# Memorandum

Re: Response to Comments to Parking Analysis for Self-storage at 9616 Universe Boulevard NW

Re: Parking Analysis for Self-storage at 9616 Universe Boulevard NW

Proposed Site Plan and Parking Calculations

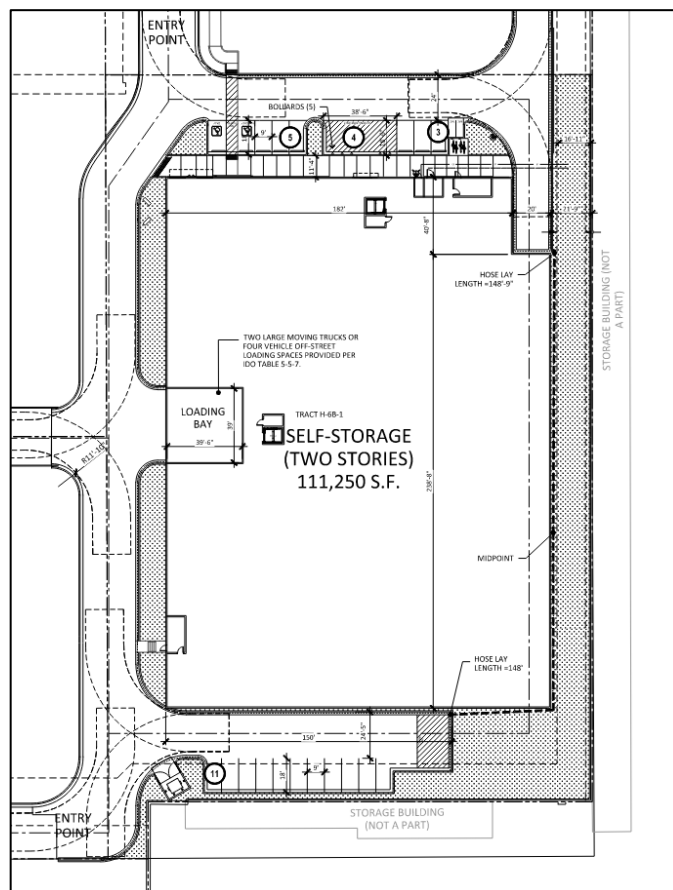
- 2) *Can you clearly show the property lines. There are currently three lots. A replat will be required combining all lots into one. Are you going to be meeting all the required setbacks under the current zoning?*

- 4) *On the notes it is mentioned that one handicap parking space is provided. Two handicap parking space as shown on the site plan should be provided based on the original required 40 parking spaces, and one must be a van handicap parking space.*

- 5) *On the north side of the building, four of the spaces are not shown as actual parking spaces. Bollards are shown within the proposed parking spaces.*

**Applicant Response:** The revised site plan shows the property line more clearly. There are not three lots. The proposed development is on Tract H-6B-1. The plat creating the tract was approved on August 16, 2024 (SD-2024-00074). AGIS until recently showed the previous lots prior to replat. The recent updates show the correct tract boundaries (see attached Plat/Address Assignment).

**Applicant Response:** The ADA Parking note on the site plan was corrected to state that two parking spaces are provided. The proposed site plan shows two ADA parking spaces including 1 van space.

**Applicant Response:** The four parking spaces are identified as loading spaces that can also be used for parking spaces if needed. The bollards are shown abutting the sidewalk.
